**PPL Bell Bend, LLC**  
38 Bomboy Lane, Suite 2  
Berwick, PA 18603  
Tel. 570.802.8102 FAX 570.802.8119  
rrsgarro@ppiweb.com

**BELL BEND NUCLEAR POWER PLANT  
RESPONSE TO RAI No. 47  
BNP-2009-292      Docket No. 52-039**

Response to NRC Request for Additional Information No. 47  
Bell Bend Nuclear Power Plant

**Figure 2-1. Assumed Evacuation Response**

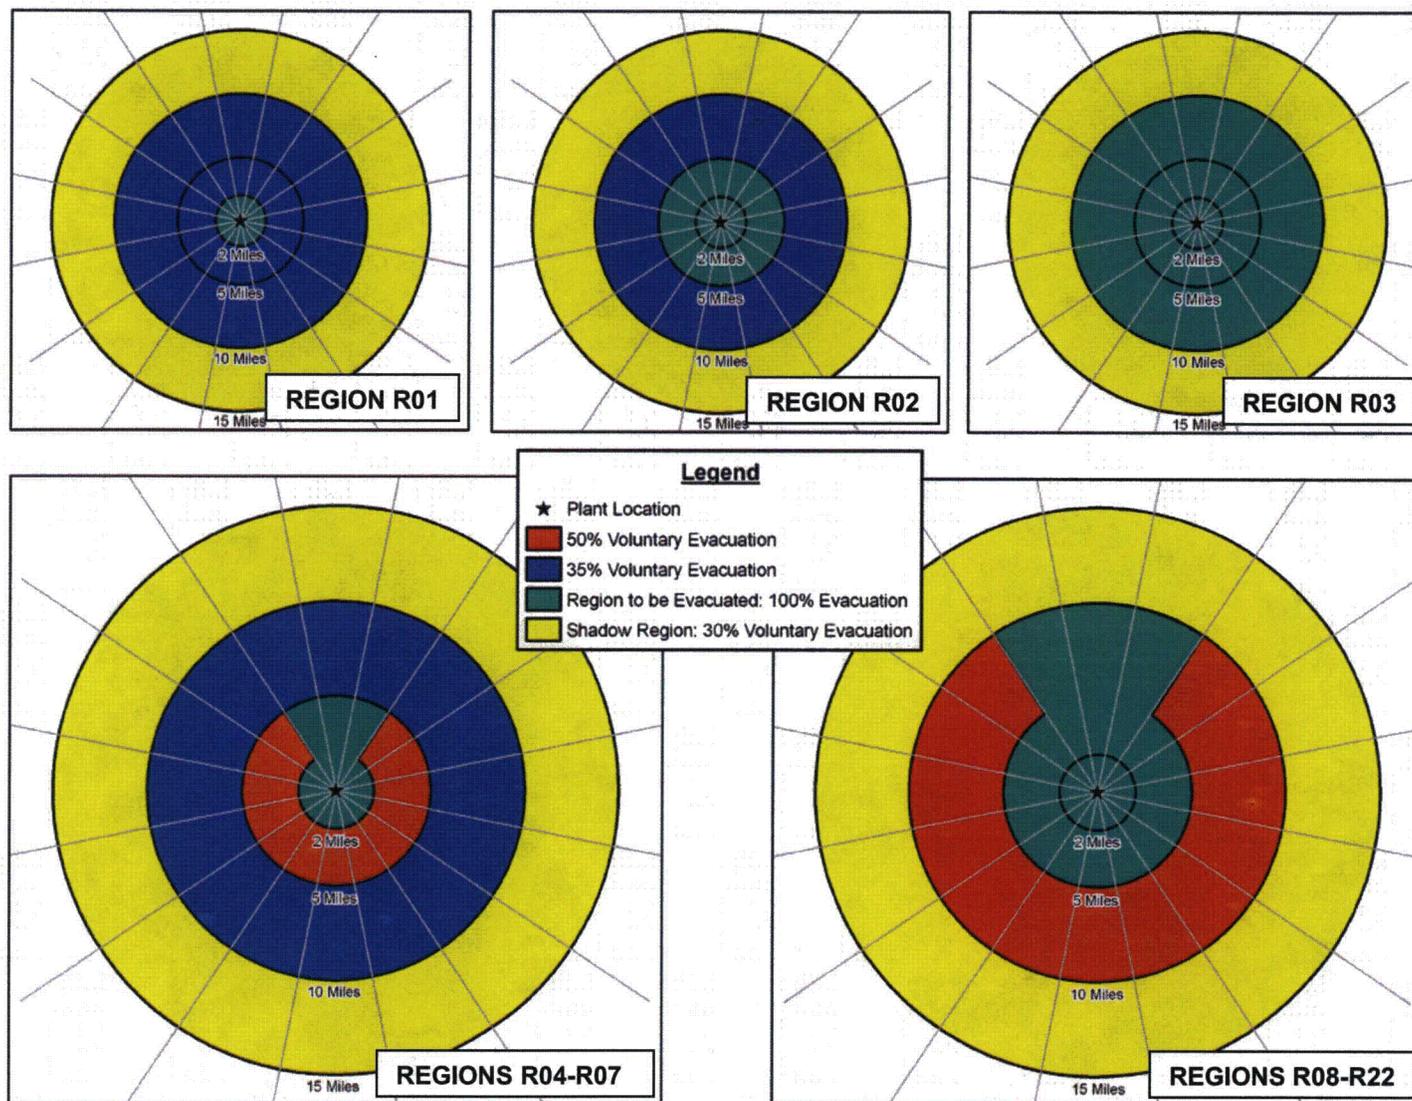
- A. Section 2, "Study Estimates and Assumptions," states that in Figure 2-1, "Assumed Evacuation Response," the area which is within the EPZ but outside the evacuation region (Regions R08-R22), will have a voluntary evacuation of 50 percent. Figure 2-1 (Regions R08-R22) shows a 35 percent voluntary evacuation rate for this area. Clarify whether the blue area depicting Regions R08-R22 in Figure 2-1 will have a 35 percent or 50 percent voluntary evacuation rate.

- A. The text in assumption 4 of Section 2.2, "Study Methodological Assumptions" is correct, stating that 50 percent of the population within the EPZ but outside the evacuation region will elect to voluntarily evacuate. For consistency with the other figures, the text will be modified to indicate that this area is red, and Figure 2-1 will be modified so that the area in question will be shaded red instead of blue.

2. Figure 2-1 will be replaced with the attached figure in a future revision of the ETE Report.

Figure 1 – School Bus Evacuation Route

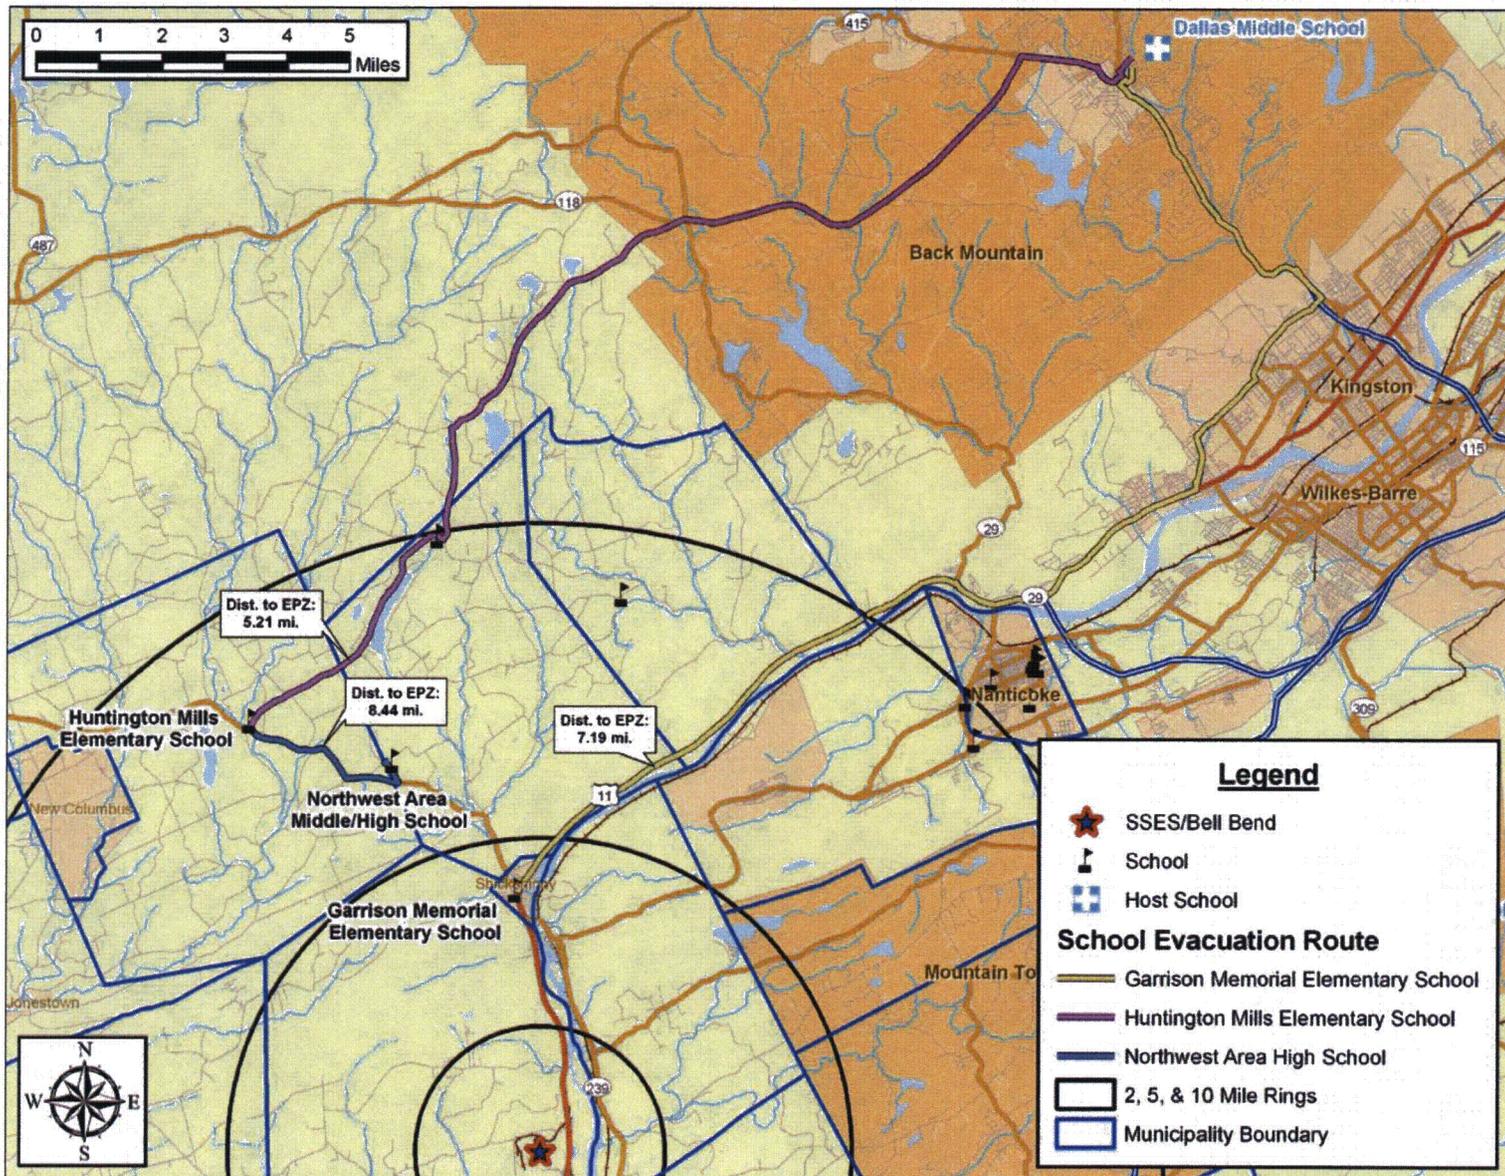
- A. Table 8-5A, "School Evacuation Time Estimates – Good Weather," indicates that the distances from Garrison Memorial Elementary School, Huntington Mills Elementary School and Northwest Area High School to the EPZ boundary is 11 miles. Discuss how traveling these distances through the EPZ reflects a generally radial evacuation, as recommended in NUREG 0654. Revise the ETE report as needed.

The attached Figure 1 shows the likely evacuation routes between the three cited schools and the host, Dallas Middle School. As presented in Figure 1, the lengths of the routes between these schools and the EPZ boundary are 7.2 mi, 8.4 mi and 5.2 mi. These routes which are generally outbound relative to the location of the nuclear power plant will be updated in a future revision of the ETE study, along with the ETE in Tables 8-5A and 8-5B.

1. Tables 8-5A and 8-5B will be updated in a future revision of the ETE Report with the updated evacuation route distances.
